Hill Street Subdivision Phase 3 Sketch Plan

PART 1: PROJECT SUMMARY

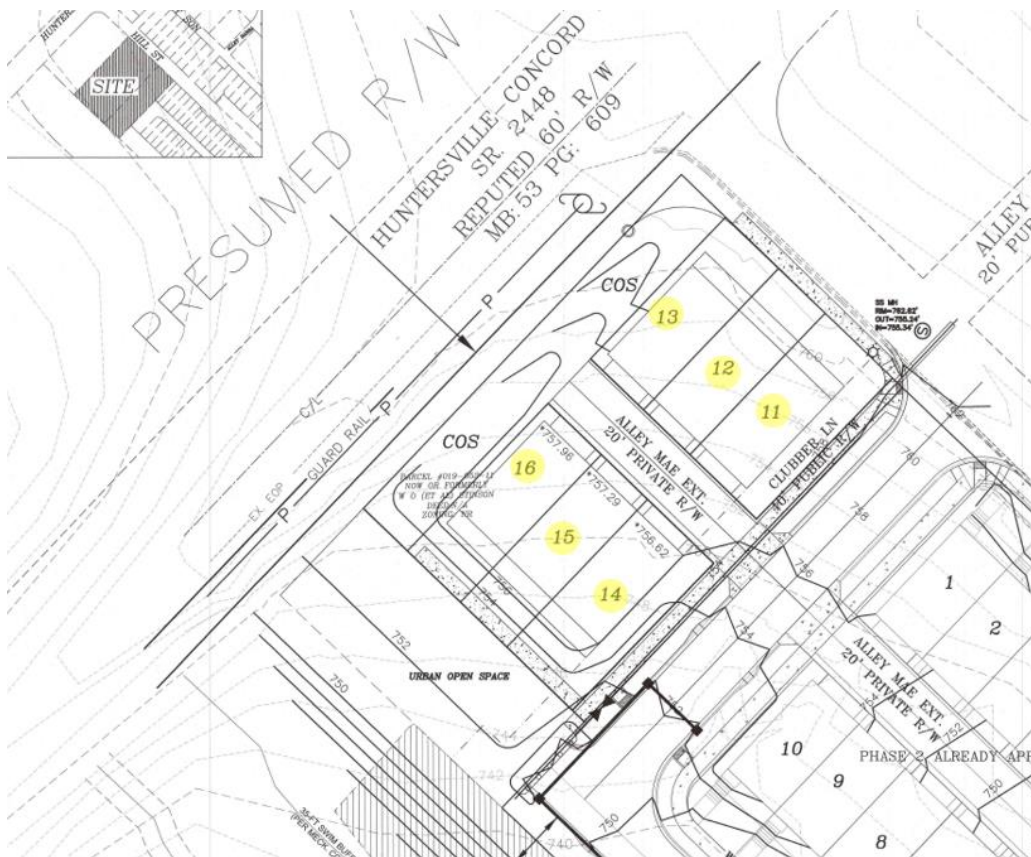
4. The proposed subdivision has 6 townhome lots, with two lot types being proposed: 4 lots with 24' wide lots & 2 lots with 21' wide lots. The average lot square footage for the development is 1,623 sq. ft.

5. There are 2 specimen trees located on the site, and neither will be retained. As the overall Hill Street development was approved prior to the Town’s tree save requirements being adopted, no tree save is required for this project. There are no known heritage trees on the site. Approximately 100% of the lot is covered by tree canopy and the developer is not proposing to save any of this area (0% required in NR-TND).

8. Required Urban Open Space is provided by a future greenway (lots 14-16 front the greenway) via one urban open space which was not identified on the plan, but which resembles a green. The developer has discussed updating the plan so that the green is replaced with a greenway. In conversations held with the developer, the greenway would connect the internal trails found in the Vermillion development to the County’s planned greenway which is projected to run parallel to Huntersville-Concord Road & to Clarke Creek to the west- though updated designs have not been shared with staff. Either urban open space type would provide frontage for lots 14-16.
